Ref: 012150 - DES-Volkswagen Hatfield

RE: Planning Approval: **6/2020/3222/MAJ**
Location: Former Volkswagen Van Centre Comet Way Hatfield AL10 9TF
Development: Demolition of existing buildings and construction of new building comprising 118 residential apartments, layout of parking areas, landscaping, electricity substation and ancillary development
Planning Compliance Condition No. 8, and 22.

Figure 2: Site Overlay of Borehole Locations

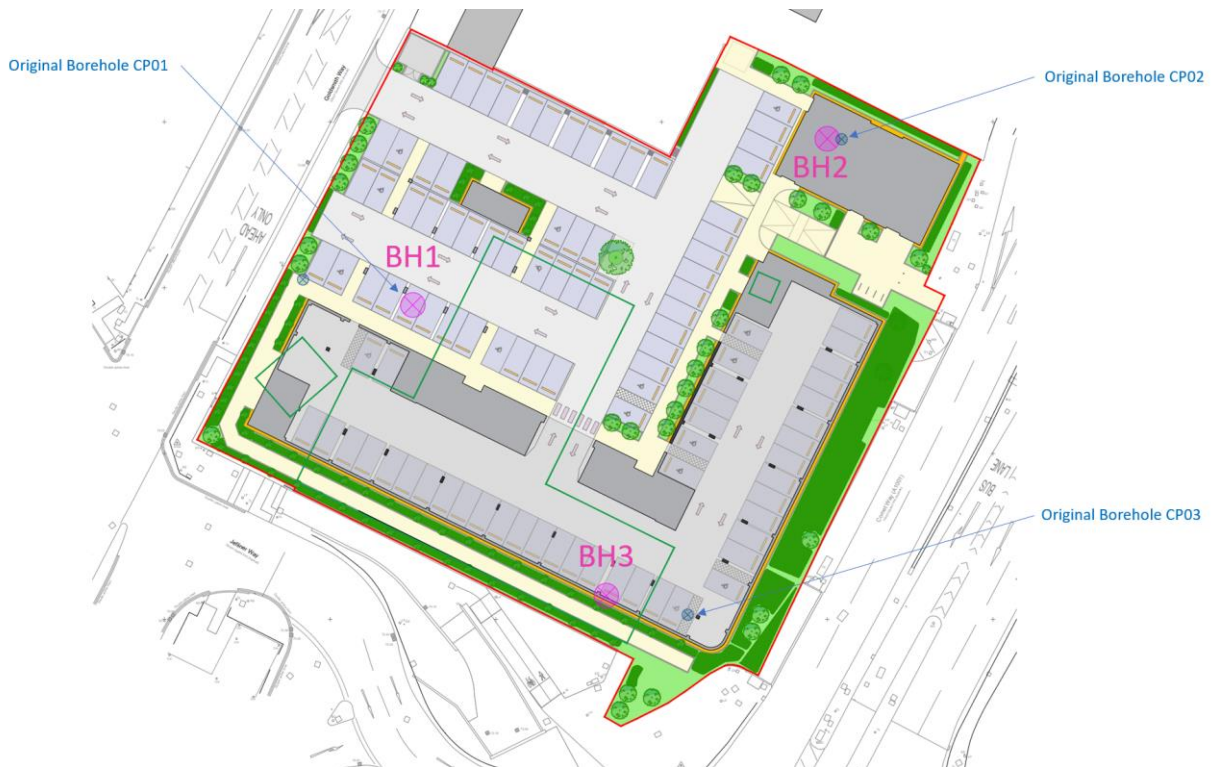
- Environment Agency letter 7 November 2022 refers to condition 8. This letter requests further information and we plan to demonstrate this using bore hole results located within the building footprint. These are boreholes carried out during this year which are newer than original available borehole results.
- Affinity Water letter 1st November 2022 also refers to condition 8. Herewith our response to include the review of the bore holes and the depths of the piles.

The original bore holes on site CP01, CP02, CP03 are marked on the attached plan in Figure 1. New Ways Ltd. commissioned Ian Farmer Associates to carry out new updated bore hole testing. These are marked on the attached plan BH1, BH2 and BH3, same Figure 1.

Figure 7: Locations of Bat and Swift Boxes

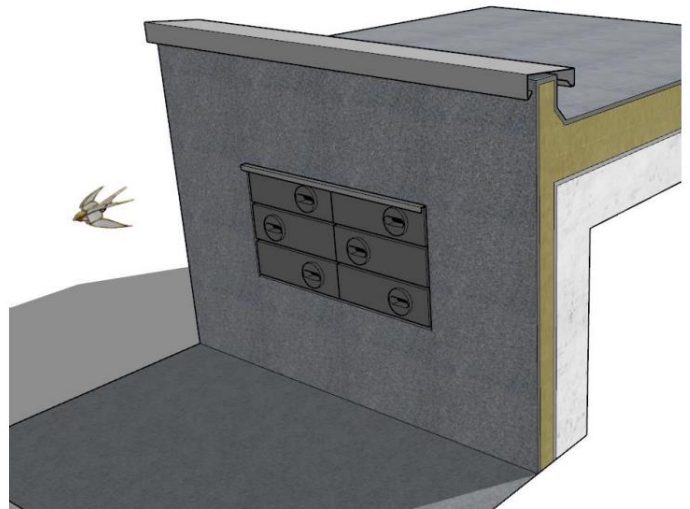
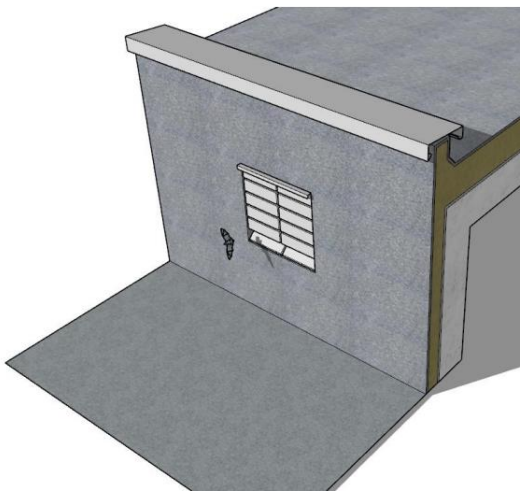
- Comment from Matt Dodds Herts and Middlesex Wildlife Trust dated 11.11.2022

We are happy to take on board the advice which refers to the bat and bird boxes and we can agree to their installation. We include the amended details on the following pages to align with the comments, Figures 7 onwards. We have incorporated the roosting spaces away from the terraces/ balconies.

South Aspect Location
2 No. Integrated Bat Boxes

North Aspect Location
6 No. Integrated Swift Boxes
